UNITED STATES
NUCLEAR REGULATORY COMMISSION
WASHINGTON, D. C. 20555

Docket No.: 50-338

SUBJECT: NRC REQUIREMENTS FOR AUXILIARY FEEDWATER SYSTEMS AT NORTH ANNA
POWER STATION, UNIT 1

NORTH ANNA UNIT 1 AUXILIARY FEEDWATER SYSTEM

Auxiliary Feedwater System
 North Anna
 Figure 1

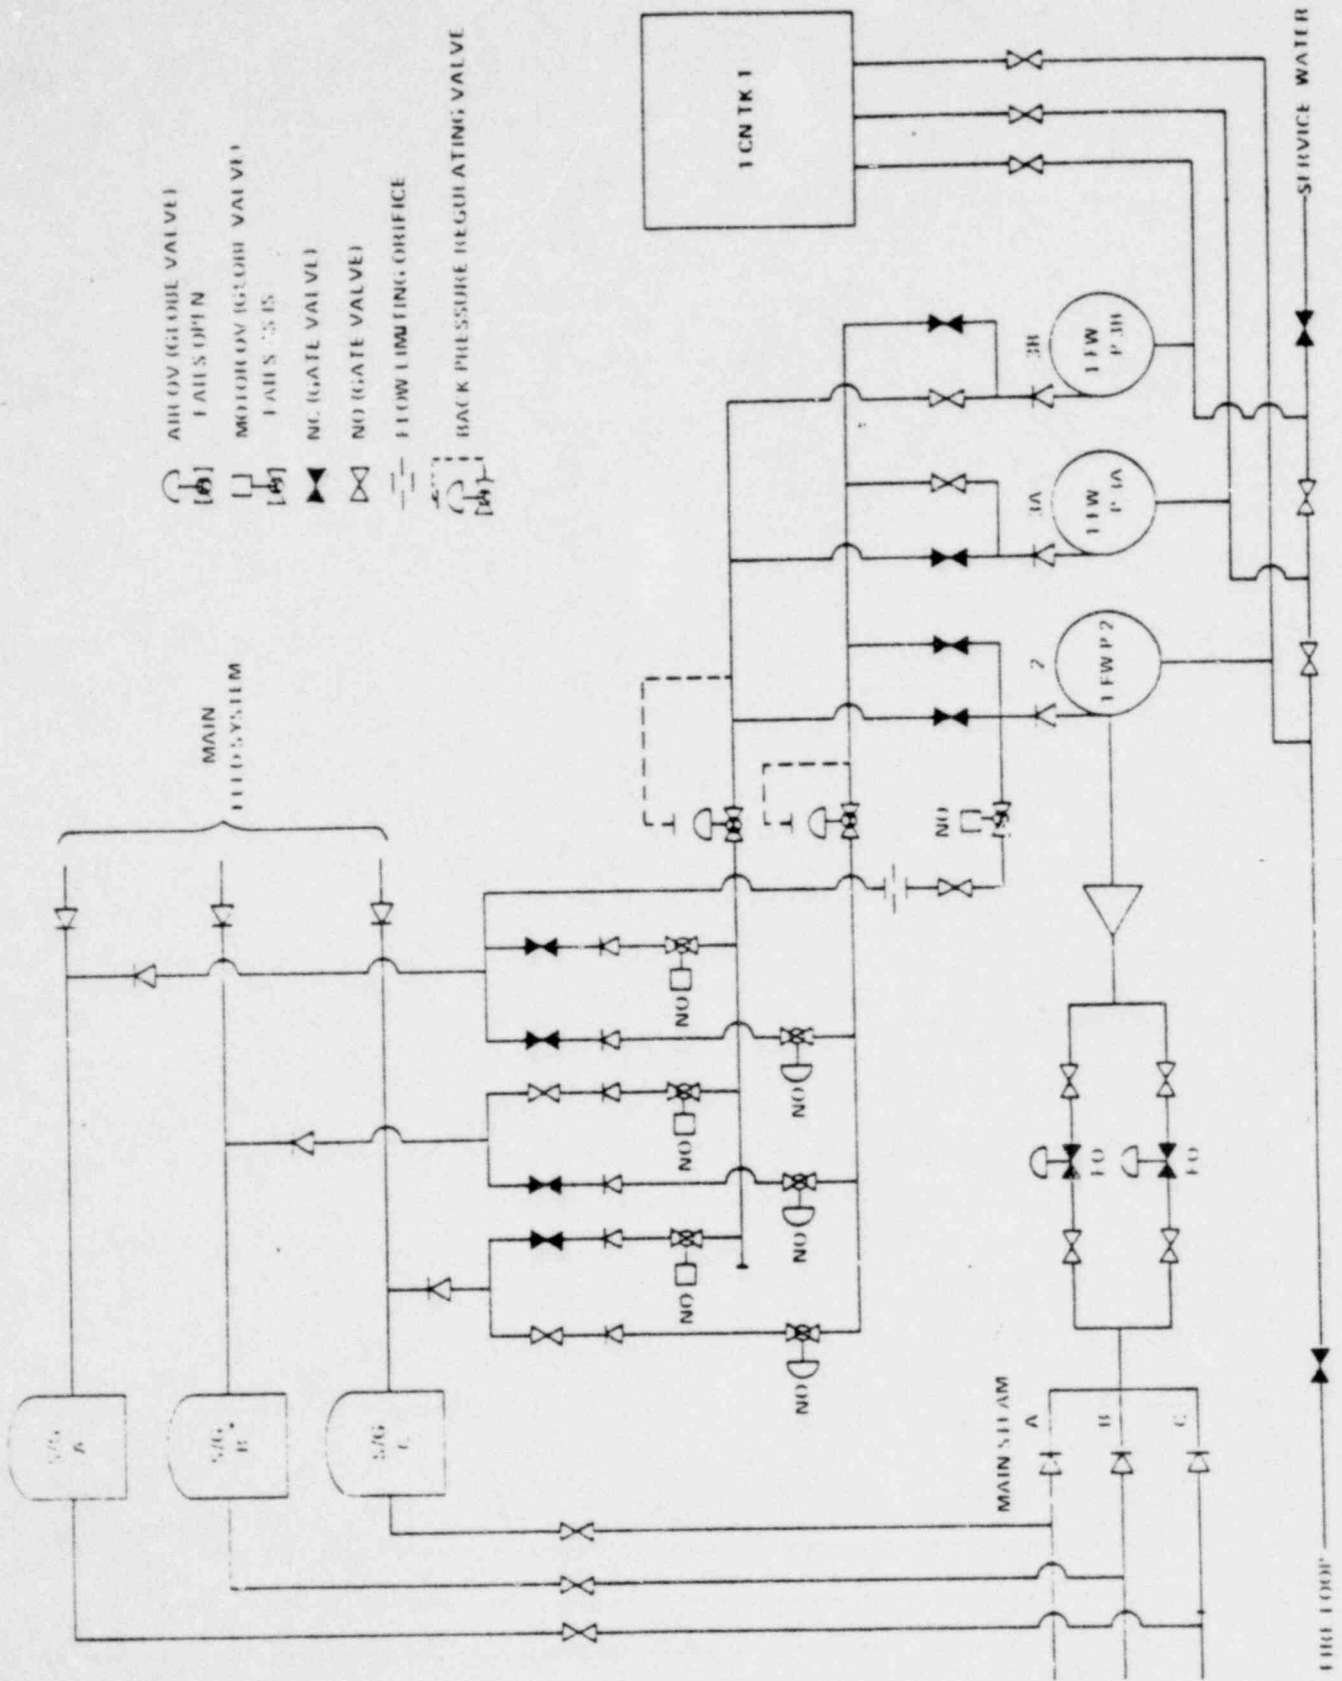
The AFWS is shown in simplified form in Figure 1 attached. The system consists of two motor driven pumps (3A, 3B), and one steam driven turbine pump (2). Each motor driven pump has a design flow of 350 gpm, the turbine driven pump has a design flow of 700 gpm but is orifice limited to 350 gpm when pumping in the normal lineup to SG-A. Taps from each main steam line at a point upstream of the main steam isolation valves provide the source of steam to the turbine. The motor driven pumps are connected to separate emergency power buses

Referring to Figure 1, each pump is lined up normally to a specific steam generator; pump 3B to SG B, 3A to SG C and 2 to SG A. The pumps can be aligned to other steam generators in the event of line breaks, pump failures, etc., by positioning the manual control valves to suit. AFW flow to steam generator C is normally remote manually controlled by an air operated valve. AFW flow to steam generators A and B is similarly manually controlled by an AC motor operated valve in each supply line. In the event of loss of offsite and onsite AC power, realignment of manual valves is necessary to supply AFW flow to all steam generators from the turbine-driven pump. The instrument air supply system, for the air operated AFW flow control valves, includes a 16.7 cu. ft. accumulator tank charged to 100 psig. This capacity is sufficient to operate the air operated valve(s) from 30 minutes to 8 hours depending on frequency of valve adjustment.
